DEVELOPMENT APPLICATION ASSESSMENT REPORT

Application Number:	DA2021/2640
----------------------------	-------------

Responsible Officer:	Olivia Ramage
Land to be developed (Address):	Lot 64 DP 18880, 35 Coles Road FRESHWATER NSW 2096
Proposed Development:	Alterations and additions to a dwelling house
Zoning:	Warringah LEP2011 - Land zoned R2 Low Density Residential
Development Permissible:	Yes
Existing Use Rights:	No
Consent Authority:	Northern Beaches Council
Land and Environment Court Action:	No
Owner:	Mark David Lindon Tennille Amy Bignell
Applicant:	Anna Williams - Your Beautiful Home

Figure 1 - Eastern Elevation showing Envelope Breach

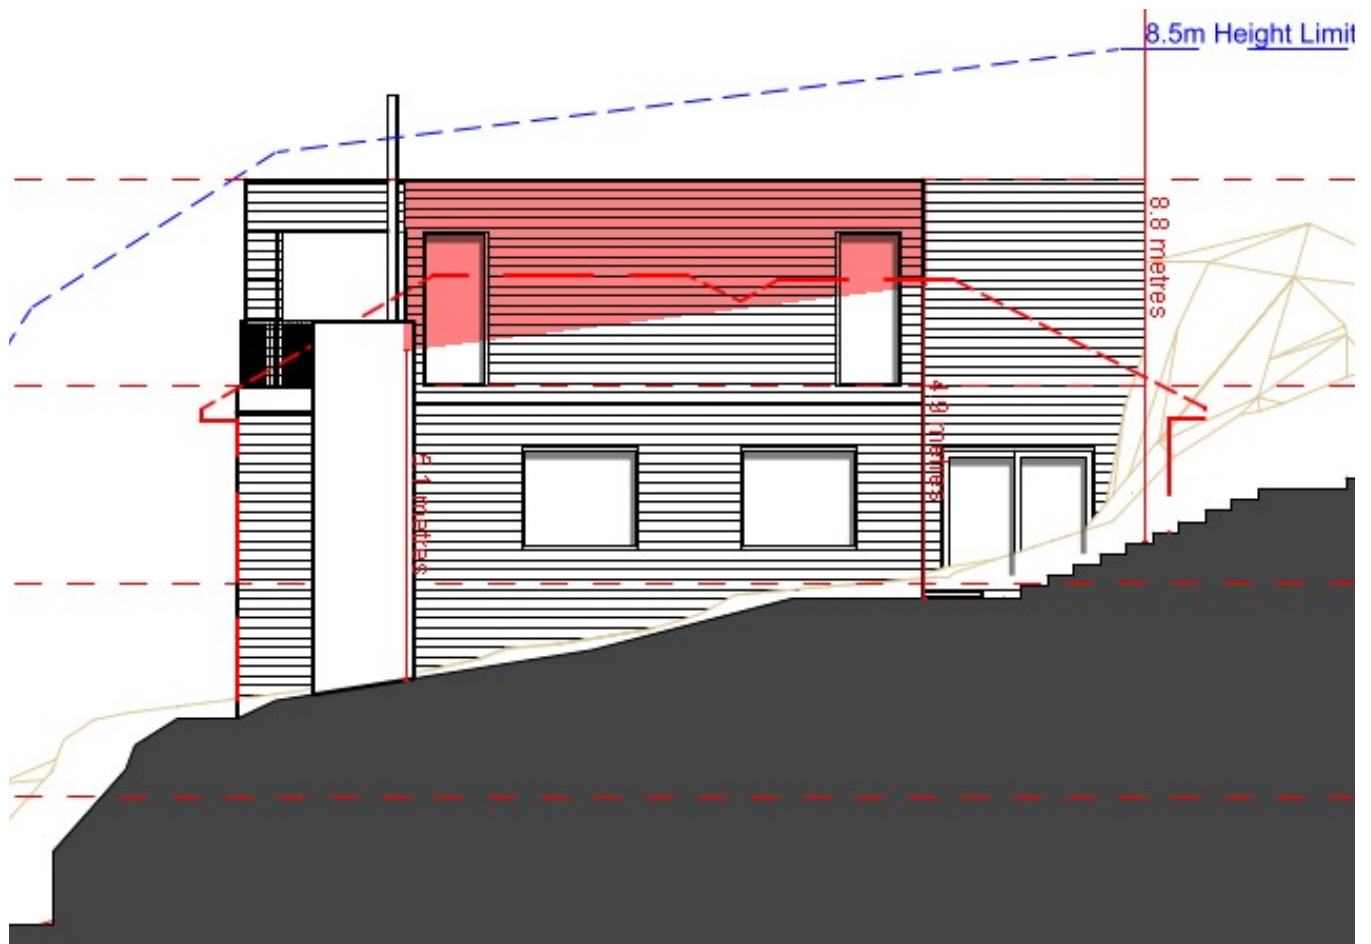
The proposed development encroaches both the eastern and western side boundary envelopes. On the eastern elevation, the encroachment is between 1.5m and 2.6m for a length of 8.0m. On the western elevation, the encroachment is between nil and 2.4m for a length of 4.8m.
